**RE: SITE PLAN – ADMINISTRATIVE DEVELOPMENT FACILITATION TEAM
PR-2024-010691, SP-2025-00031
7520 RAINBOW BLVD NW; LT 11-A BLK 2 PLAT OF LTS 10-A, 11-A, 19-A THRU 22-A BLK
2 UNIT 14 VOLCANO CLIFFS SUBD CONT 2.0312 AC**

Please see responses to DFT comments for **PR-2024-010691, SP-2025-00031**.
Also included are the updated construction drawings to address the comments.

2 EXTERIOR ELEVATION & PROFILE PLAN - EAST
A202 SCALE: 1" = 10'-0"

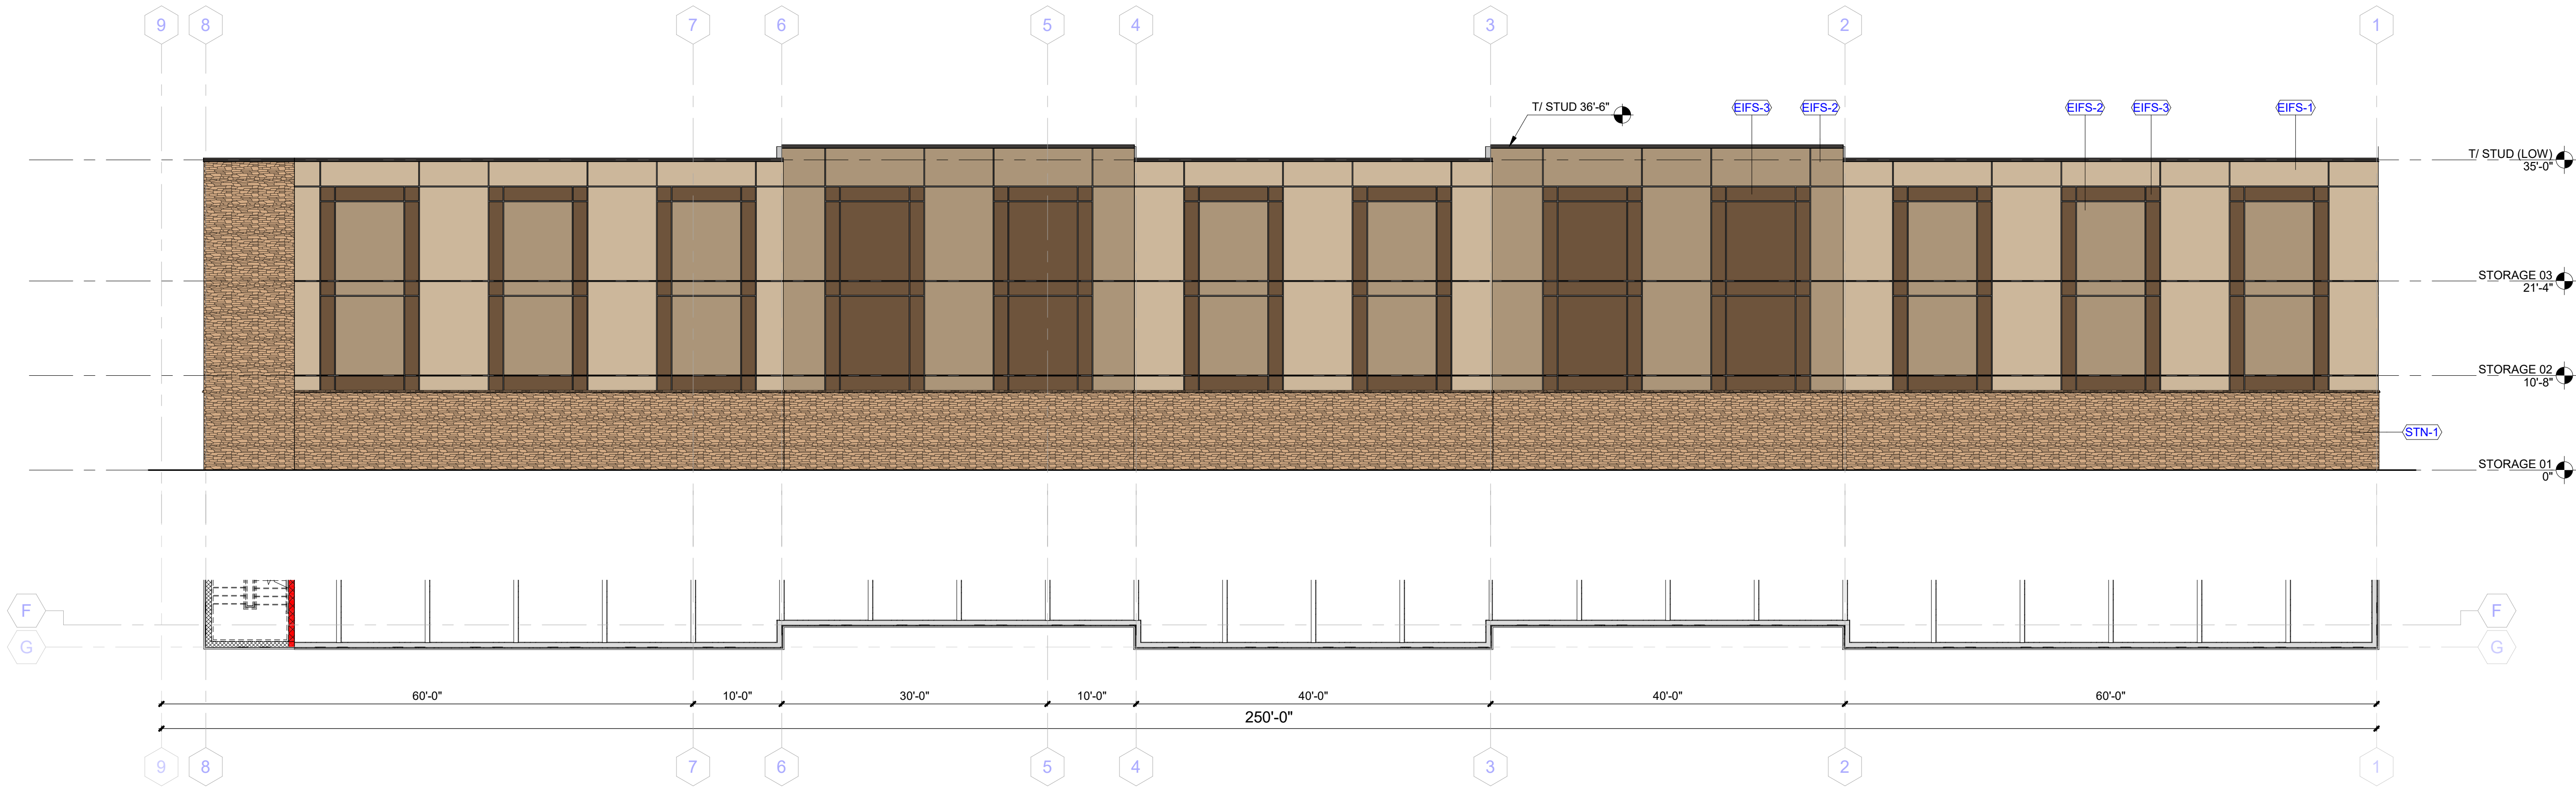
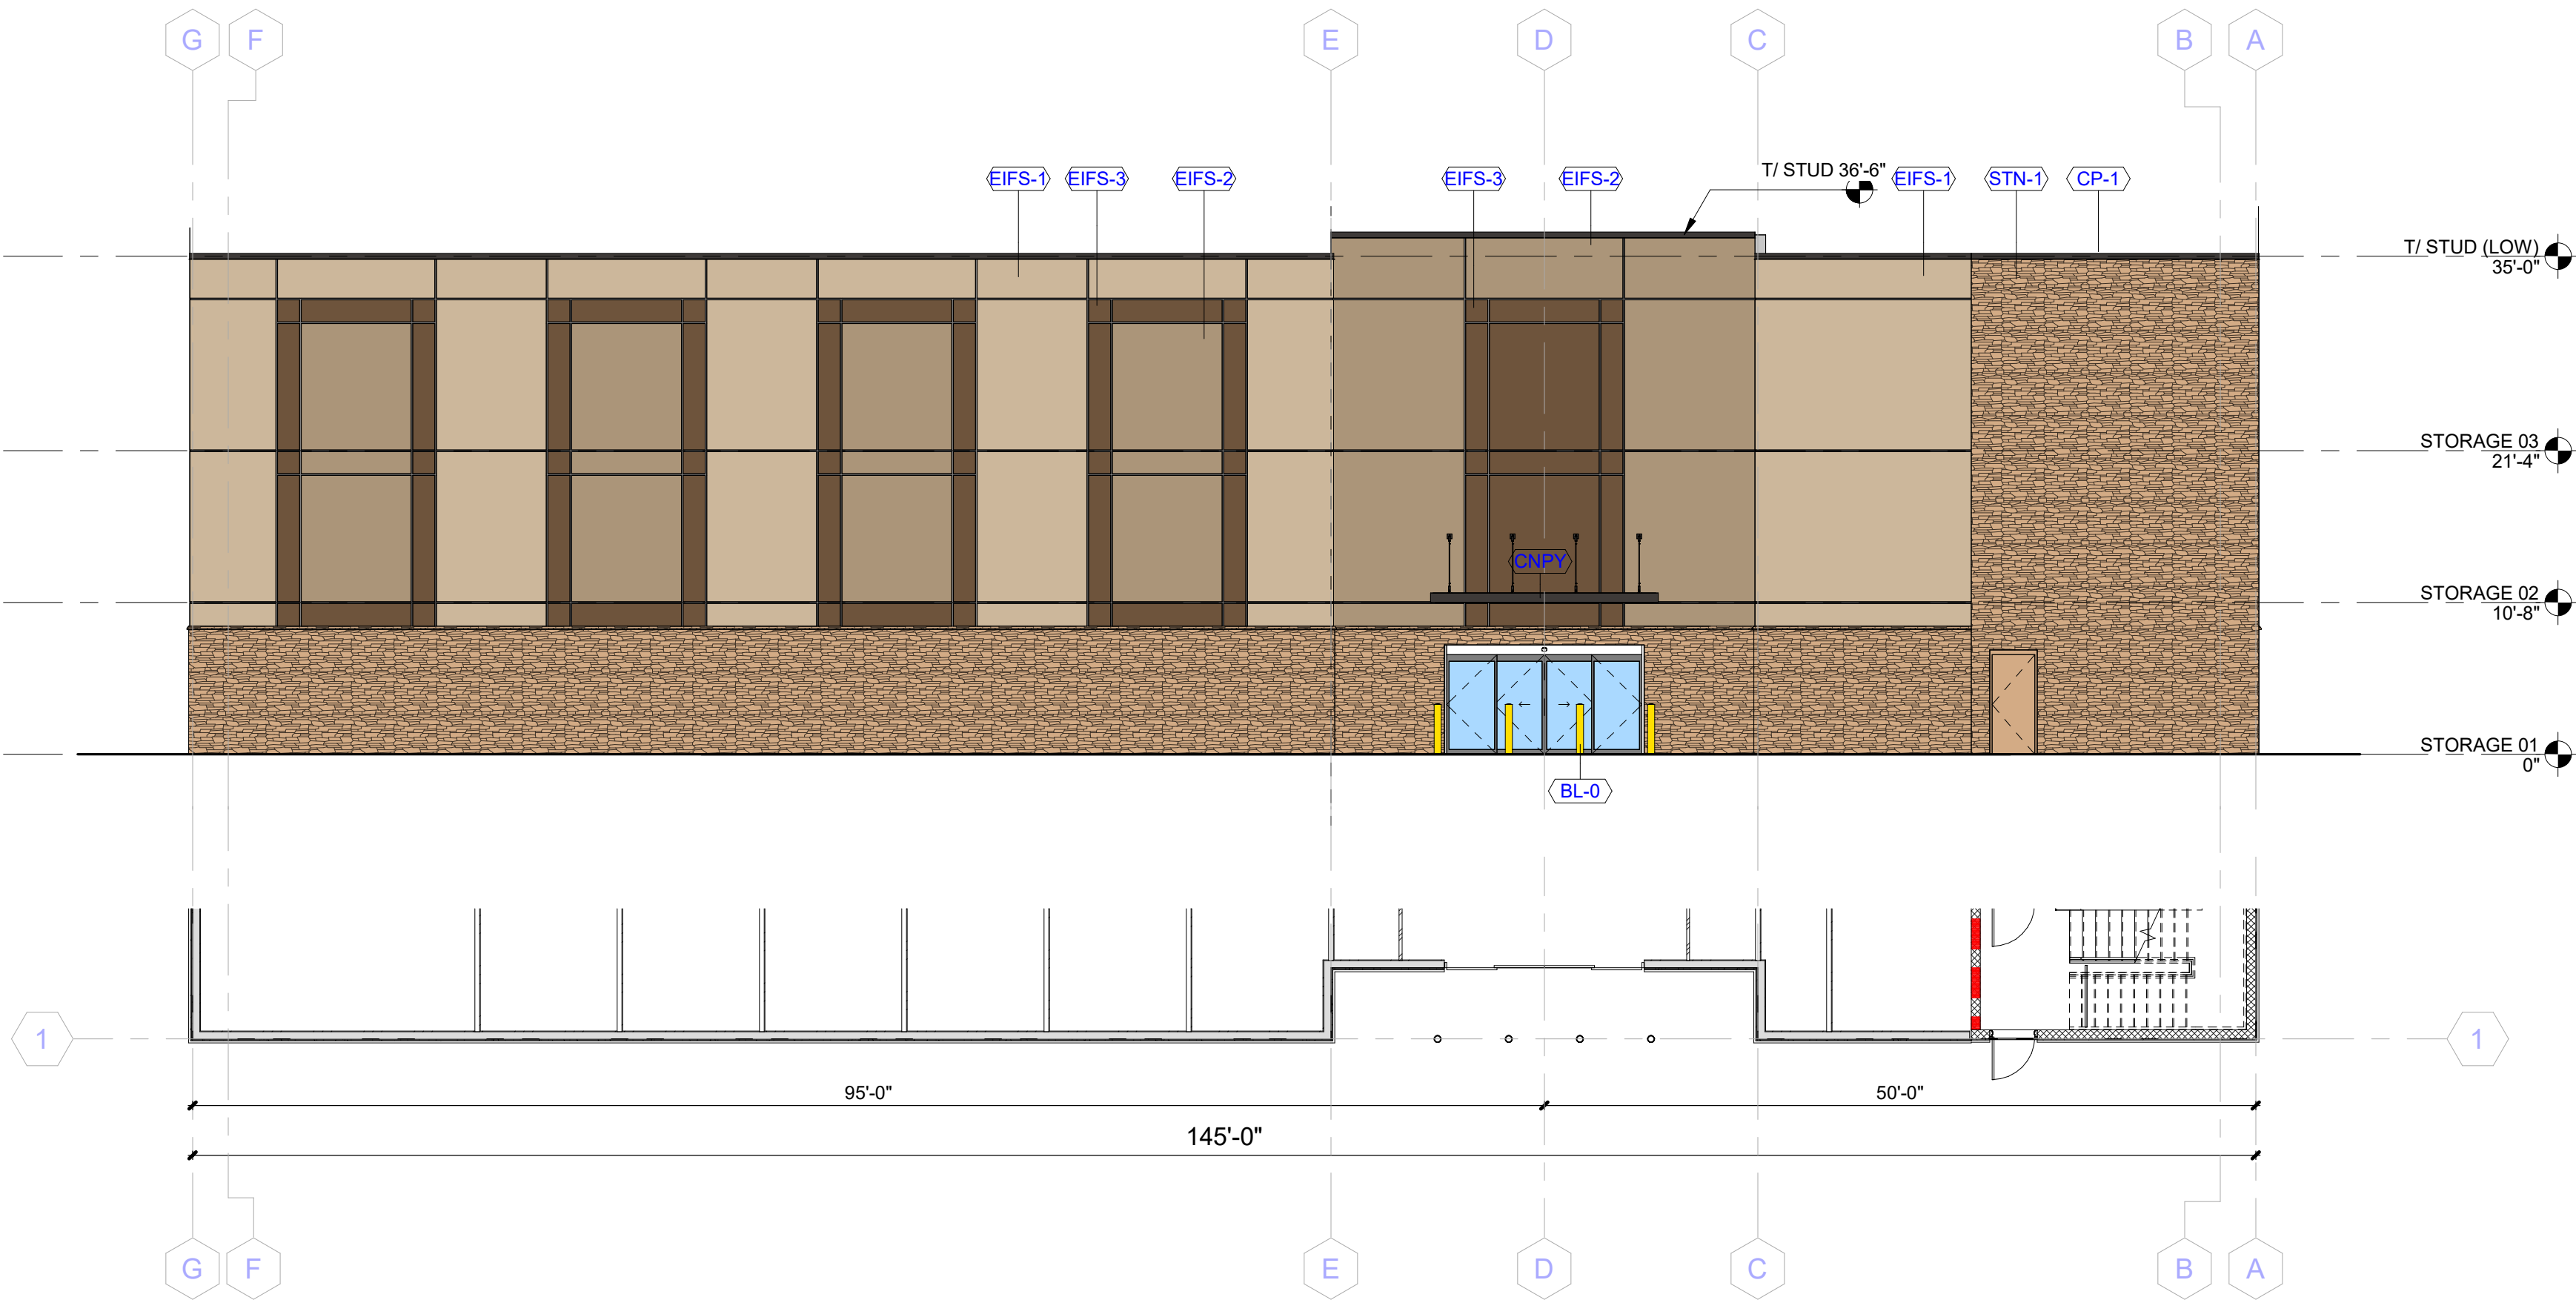
15. Elevation pages need to include details on how the project will be meeting IDO section 3-6-(E) Northwest Mesas Escarpment; specifically, 6-6(E)(5). Provide additional elevation detail to demonstrate and explain compliance with all sections within 5-11-E. Specifically 5-11-(E)(2) and 5-11(E)(3)(a)(2).

RESPONSE: See updated Elevation sheets highlighting color pallet from section 3-6(E)(5). All dimensional standards in section 3-6-(E), 5-11-(E)(2), and 5-11(E)(3)(a)(2) are met, see dimensions.
